AMBASSADOR CONSTRUCTION CO., INC.

Re: Mayor's Office of Emergency Management
7 World Trade Center
Change Order #088
Amb. Job #S57-5175

SECTION - FUEL OIL TANK RM

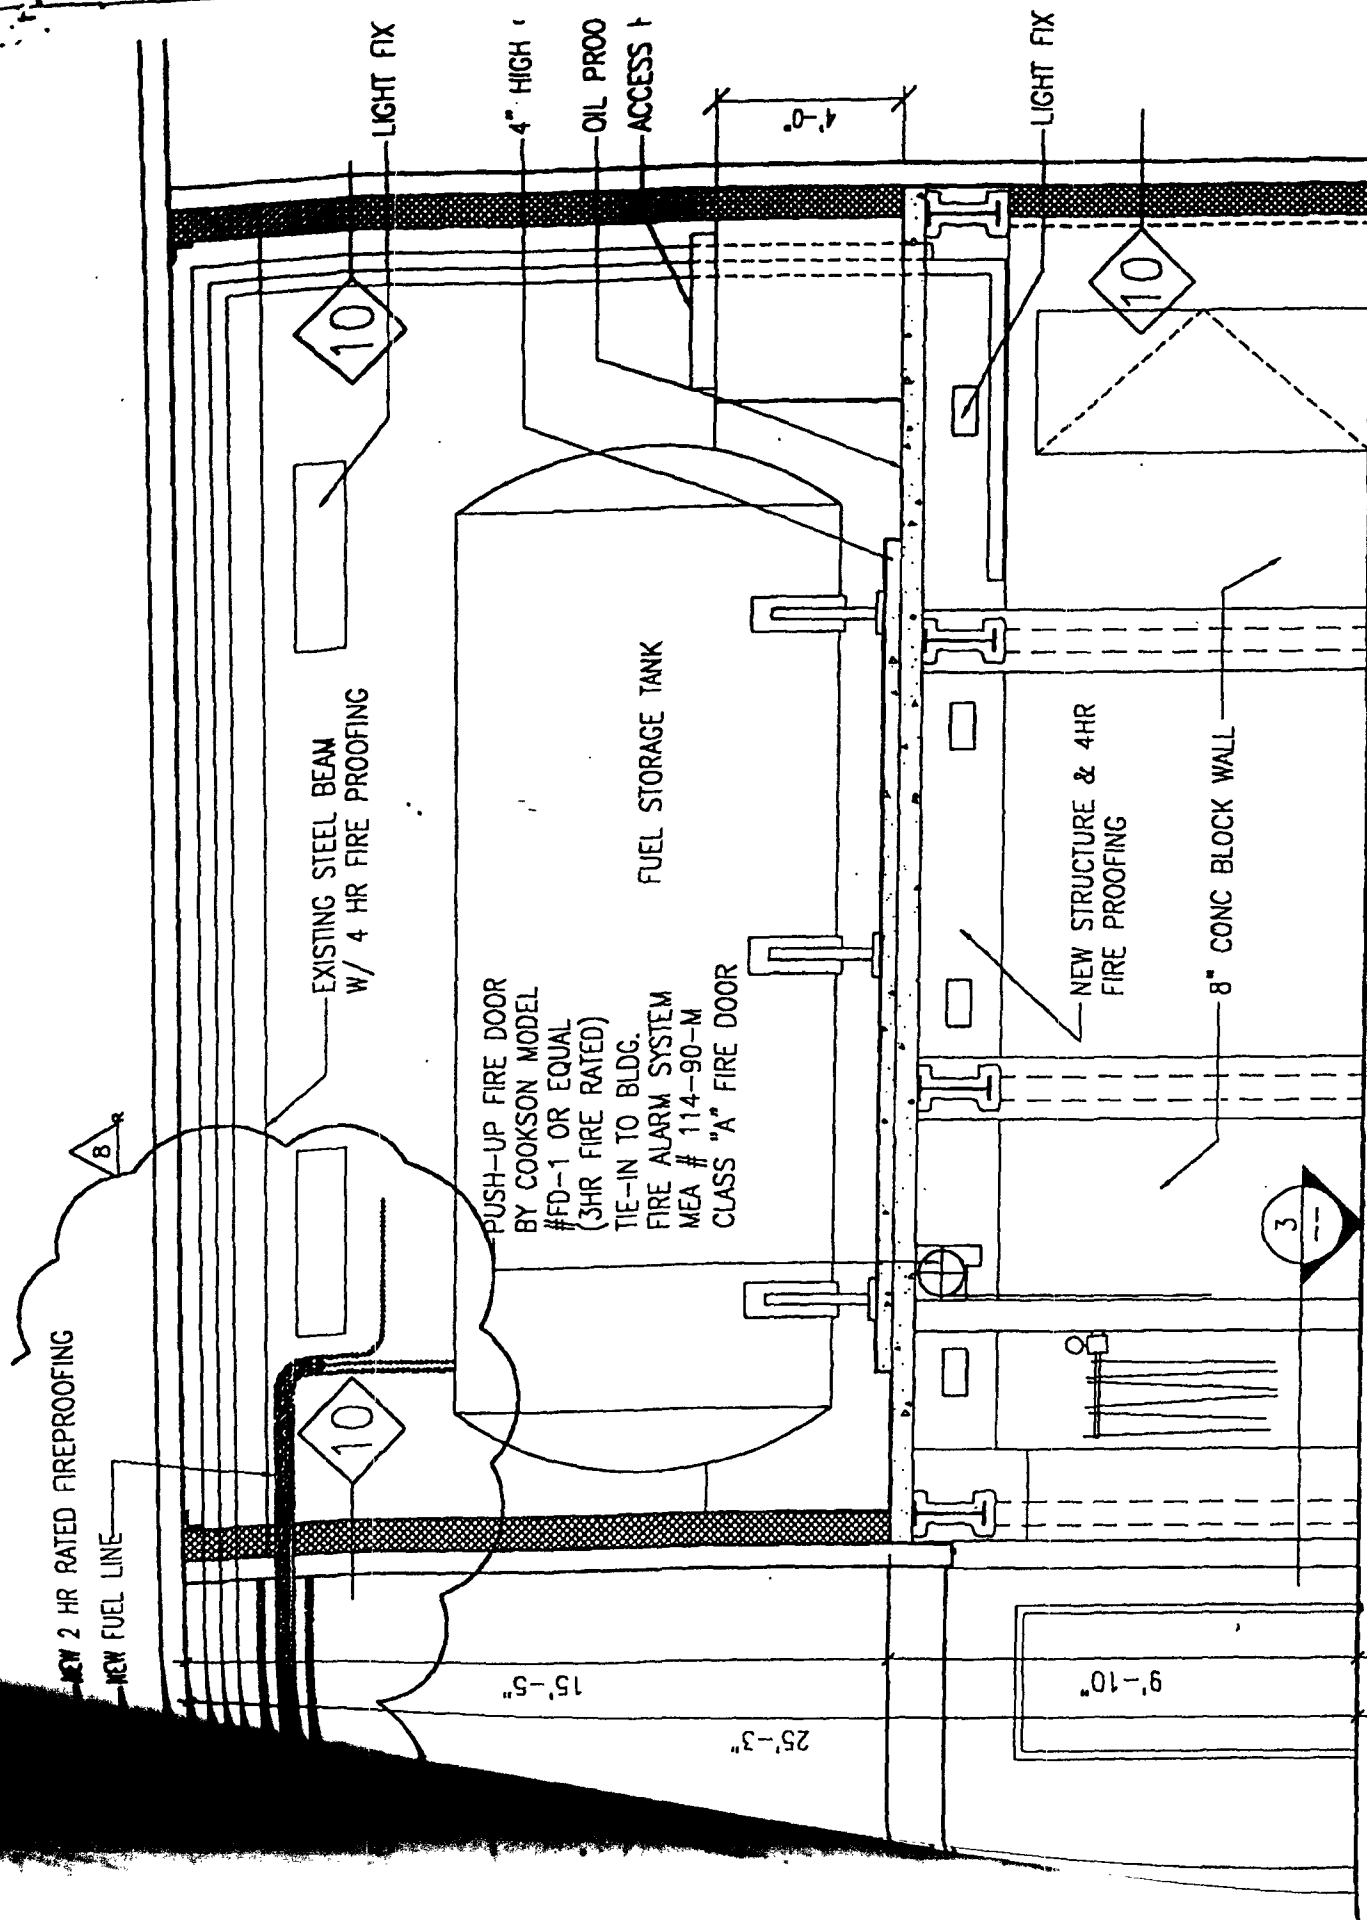
20' LIMIT HT. # (4) 16" o.c. MAX. VEF
W/ HORIZONTAL MASONRY REINFORCING
